Review of existing network and development

Essex County Council's cycling development officer has asked Witham Cycle Campaign to comment on the progress of the Witham Cycle Network as approved by the Witham Area Environment and planning committee on 13th May 1997 after public consultation.

Witham Cycle Campaign reviews the Witham Cycle Network - Part 1

Figure 1 - 1997 plan

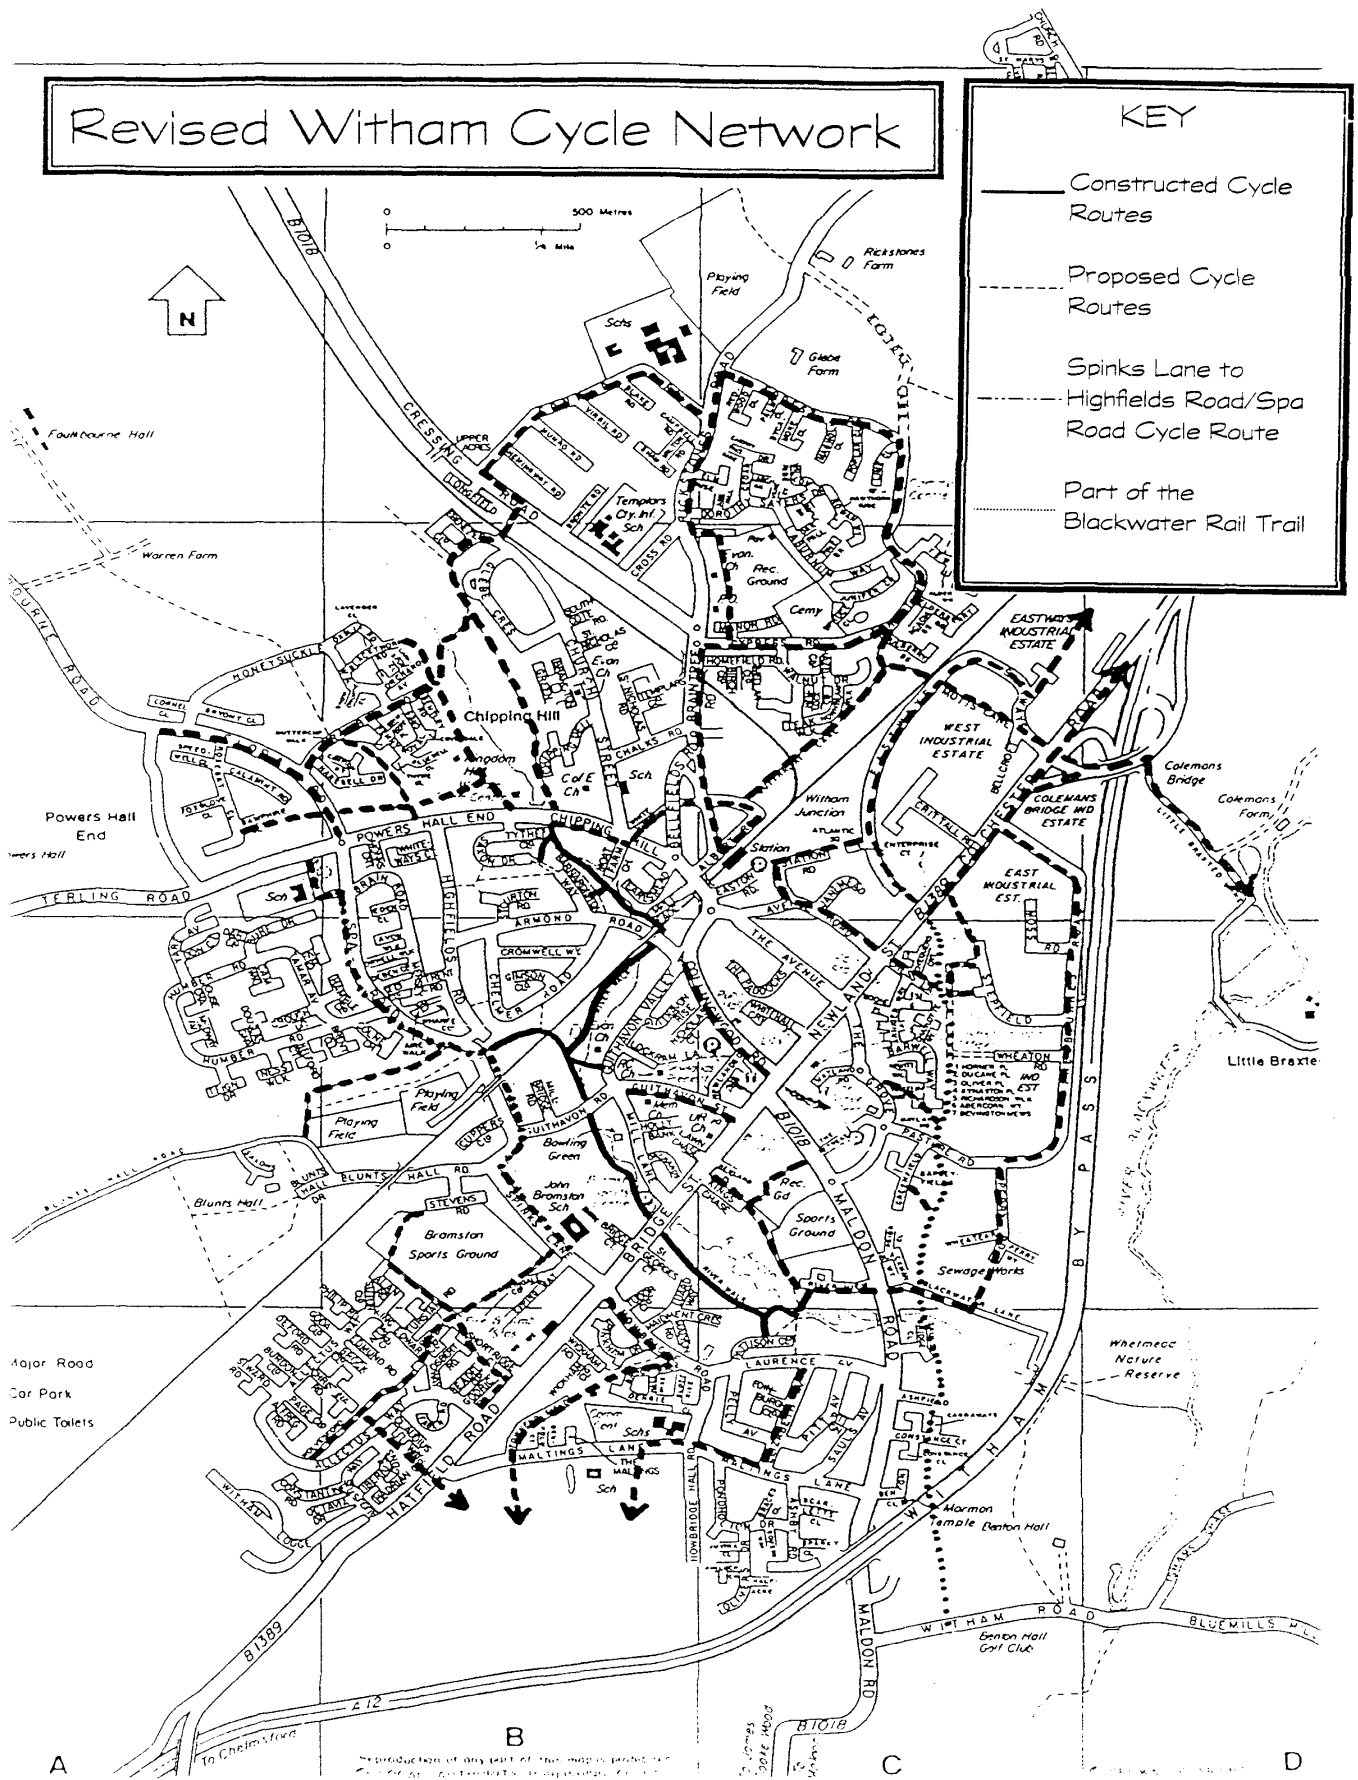
The following routes marked on figure 1 should be removed from special cycling treatment for routes. (There may still be a case for special facilities at junctions.)

- Conrad Road, Rickstones Road, Forest Road, Cypress Road.
- Flora Road, Bramble Road.
- Avenue Road
- Howbridge Road, Maltings Lane, Elizabeth Avenue.
- Guithavon St. (While two-way)
- White Horse Lane, Albert Road

- Eastways and Freebornes Road

- a section of contraflow in Braintree Road to the railway station which should probably be re-thought,
- a segment of route along White Horse Lane which needs engineering work if it is to be a reasonable junction,
- vagueness at the top of Collingwood road where there is a tricky junction with Guithavon Valley
- a West-side lane on the remainder of Collingwood Road to the traffic lights which is not particularly hazardous. This segment needs a complete re-think to put the right facilities where they are most needed.

The '97 plan show a break just where it would be expected to join up with the existing north end of the river walk. Careful thought needs to go into designing the crossing over Powers Hall End Road including the possibility of routing straight across the bottom of Powers Hall End at Spring lodge into Tythe Close thence onto the River Walk route.

The plan shows a route running East from the Flora Road underpass. If this was shared use then we can expect problems with cyclists travelling too fast down the hill.

The plan shows a route along the east side just south of the railway bridge. This short section may not be justified.

As discussed above, there should not be a need for a Howbridge road cycle lane as marked on the plan.

The '97 plan shows a cycle route on the east side from the mini-roundabout to the old bridge. In theory this would be an excellent place to have a dedicated lane as cyclists are going much slower than the rest of the traffic at this point. However unless it is full width or located properly on the verge it will not be very safe. Therefore this section should be properly surveyed to examine the practicalities.
